SERVICE BULLETIN NO. 226

Kodak AUTOMATIC FILM FEEDER, MODEL RA

DIP SWITCH Location Changed on the ADJUSTMENT CIRCUIT BOARD

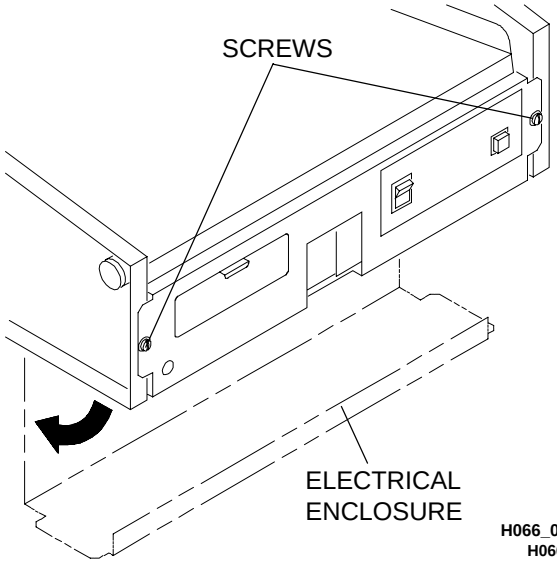
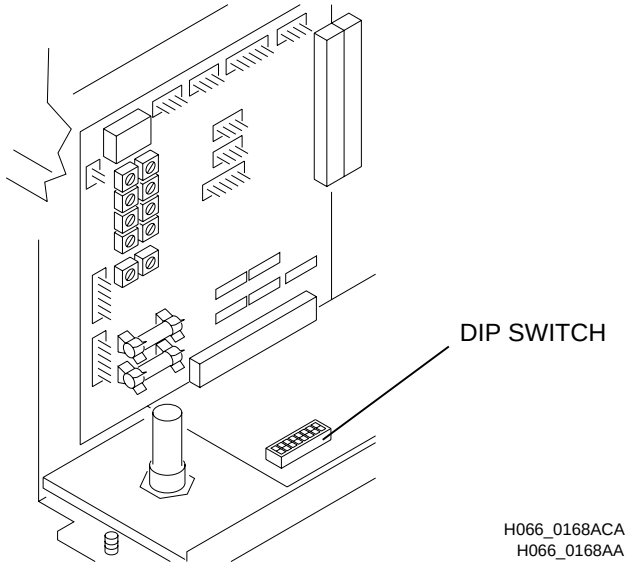
To reduce the effect of electrostatic discharge on the FILM FEEDER, the DIP SWITCHES have been relocated on the ADJUSTMENT CIRCUIT BOARD. On current units, the SWITCHES are located on the ADJUSTMENT CIRCUIT BOARD so that they are inside the ELECTRICAL ENCLOSURE. See the illustration. The DIP SWITCHES are not accessible through the FRONT PANEL.

On FEEDERS with Serial No. 50,899 and above, the DIP SWITCHES are inside the ELECTRICAL ENCLOSURE. See the figures below.
